METROPOLITAN GOVERNMENT OF NASHVILLE AND DAVIDSON COUNTY

STAFF RECOMMENDATION
308-310 Broadway
July 21, 2021

Application: Alteration—Windows, Lighting, and Signage
District: Broadway Historic Preservation Zoning Overlay
Council District: 19
Base Zoning: DTC
Map and Parcel Number: 09306202600
Applicant: 306 Broadway, LLC, property owner
Project Lead: Melissa Sajid, melissa.sajid@nashville.gov

Figure 3. Completed work.

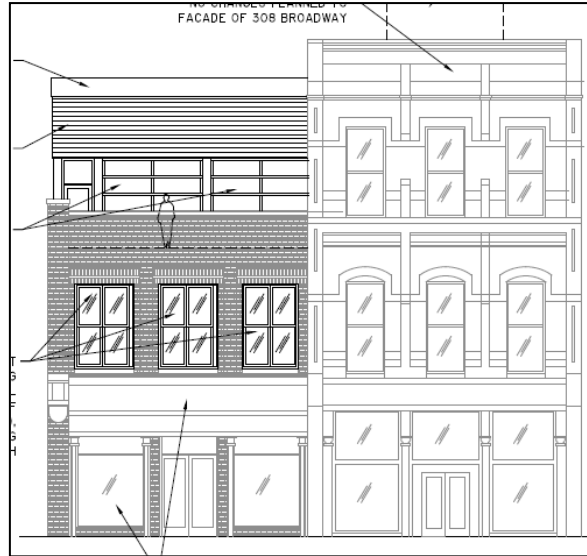
Windows: Windows were installed on the second-level of the front façade without a permit and include fixed and roll up windows. (See Figures 2 and 3). According to Section II.A.4, replacement windows should be should have single-light or multiple-light clear-glass panes to match the style and period of the building. In this case, a single or double hung window would be appropriate for the style of the building (Figure 4). Roll up doors on upper levels are not seen in the district historically, and the Commission has not approved such windows for upper levels, or for Broadway facing elevations, in the past.

Lighting: All proposed lighting should be simple and unobtrusive in both material and appearance. The new string lights, which were also installed without a permit, are located in a highly visible location on the rooftop addition (Figure). While they are made from a dark material as the guidelines suggest, they are overall not appropriate due to their location. The lighting and associated poles also do not comply with the guidelines for Additions, III.A.2 as they are located in the thirty-foot (30') stepback area where there should be no construction in order to lessen the visual impact of the rooftop addition.

Recommendation Summary: Staff recommends disapproval of the windows and lighting, finding that they do not meet Section II and Section III. of the design guidelines for Rehabilitation. Staff recommends that the unpermitted windows and lighting with the associated poles be removed and the menu signs changed to not exceed a total of five square feet (5 sq. ft.) within 60 days of the Commission's decision.
